Reviewer 1

The comments of Reviewer 1, along with our responses to each comment, are included below:

“This work presents a boundary optimal control strategy for axial tubular reactors with first-order irreversible chemical reaction incorporating a delayed recycle stream. The mathematical description takes the form of a system of coupled parabolic and hyperbolic PDEs. An infinite-dimensional approach is applied to derive a linear quadratic regulator with and without observer. Numerical studies show that the proposed controller is able to stabilize the system. The manuscript is clear and well written and addresses a challenging control problem in chemical engineering. The following comments and suggestions may improve the presentation so that it is considered for publication.”

Figure 1: Concentration profile along the recycle stream

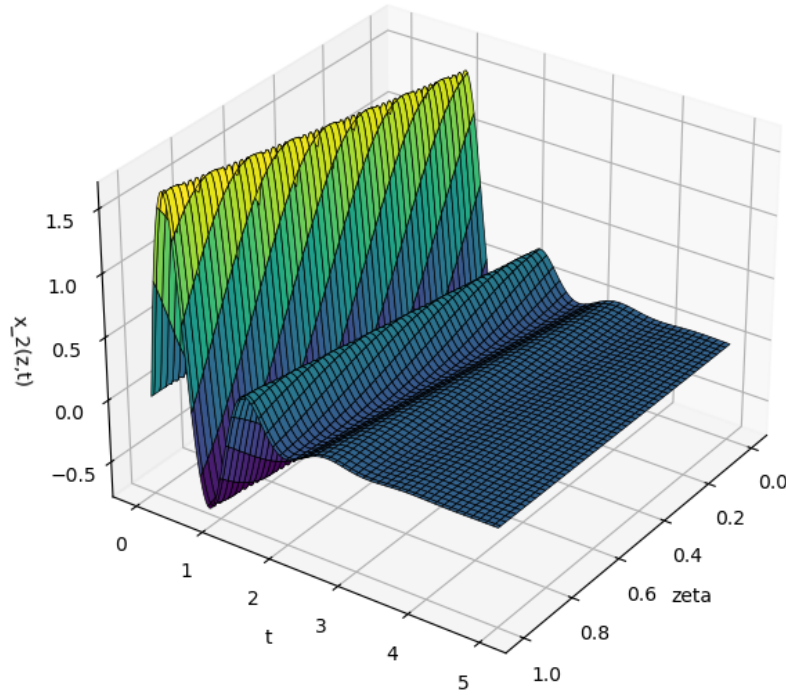
6. Page 7 - " $x_2(\zeta, t)$ is introduced as a new state variable to account for the concentration along the recycle stream"

- Why is x_2 a function of ζ ? How does x_2 change across the recycle? What kind of law does it follow? To me, it seems like x_2 only changes with respect to time

We have assumed that along the recycle stream, the flow of the reactant belongs to the class of pure transport PDEs. This is the case when the diffusion term and the reaction term become negligible compared to the convective term, and the state variable x_2 is merely being transported along the recycle stream. Nevertheless, this still implies that x_2 is a function of ζ and t . Concentration profile along the recycle stream has not been presented in the original submission as we believe it is not the focus of this work. However, for the reviewer's reference, it is included here in the response as shown in Fig. 1.

Figure 2: Axial tubular reactor with recycle stream.

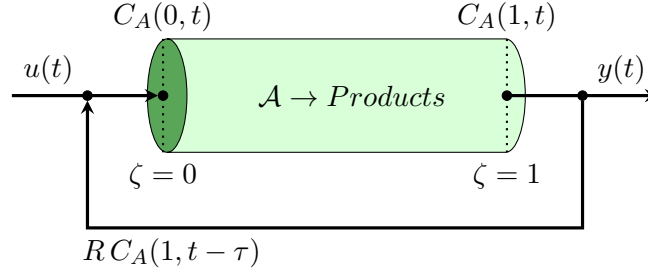
11. Page 18 - unstable dynamics of the model

- Why is the zero-input response considered unstable? Is it a qualitative assessment? What is the physical meaning of Figure 9?

For the axial dispersion tubular reactor presented in Fig. 2, the molar balance equation may be written for the reactant concentration, C_A , as follows:

As a result, the zero-input response is considered unstable due to the positive reaction term in the model. Figure 9 illustrates the unstable dynamics of the linearized model in the vicinity of the steady-state in the absence of control input; with the qualitative assessment that a deviation from the steady state may draw the system to a different steady state, resulting in completely different model dynamics than the one used to design and control the system for optimal operation. The manuscript has been updated to include more detailed explanation in this regard.
